Modifications for the Kenwood TS-820

TS-820 RIT modification

Service bulletin no. 13 (27-1-1977)

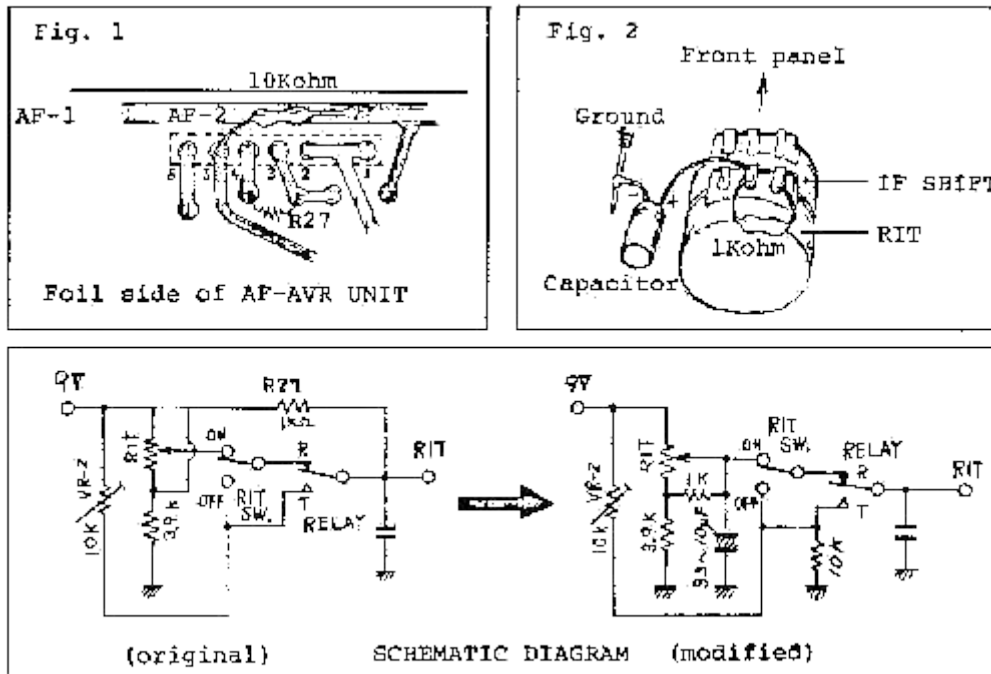
We have had a few reports of the TS-820 RIT tuning being "rubbery". The following information will solve this.

1. Remove resistor R27 (1Kohm) on AF-AVR unit (X49-1080-00).
2. Install a 10Kohm resistor on foil side of AF-AVR unit. See figure 1.
3. Install a 1 Kohm resistor on RIT control. See figure 2.
4. Install a capacitor (3.3uF - 10uF) between RIT control and ground. See figure 2.
5. Adjust VR-2 on AF-AVR unit (X49-1080-00) for the same frequency as the center position of the RIT control.

Microphone input attenuator for TS-820

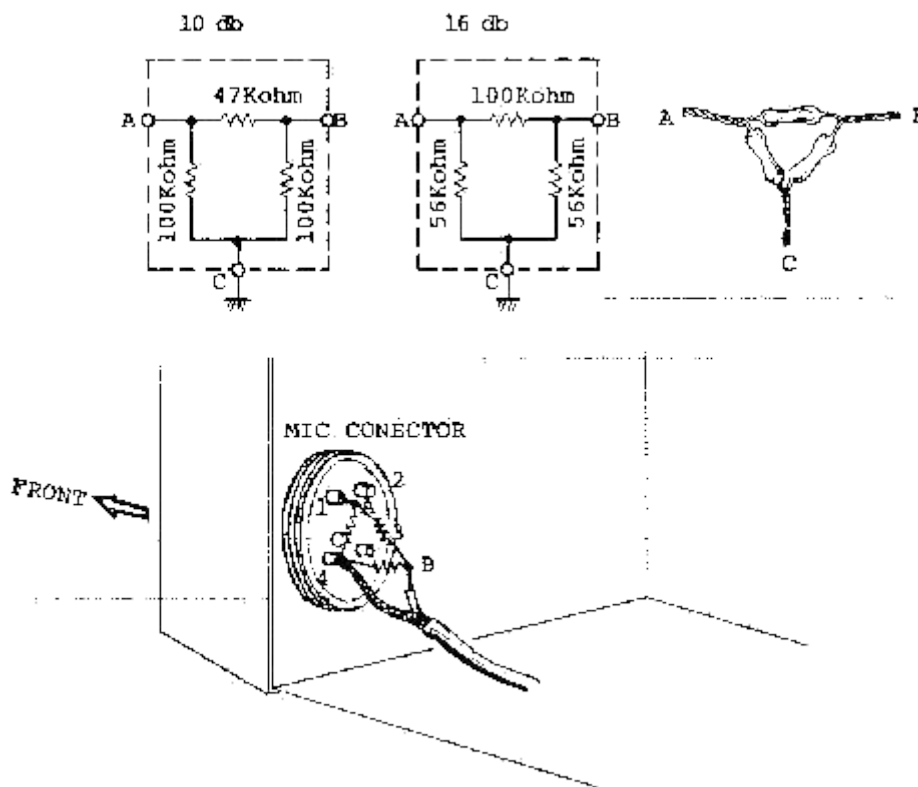
When using a high output microphone (i.e. Shure 444), it is very likely that there will be distortion of the transmitted audio if the processor is used. The reason the distortion occurs is because the processor is between the first microphone amplifier and the microphone gain control. The installation of one of the attenuators shown below will reduce the microphone input to a level that will not cause RF speech processor distortion. The attenuator figures are approximate.
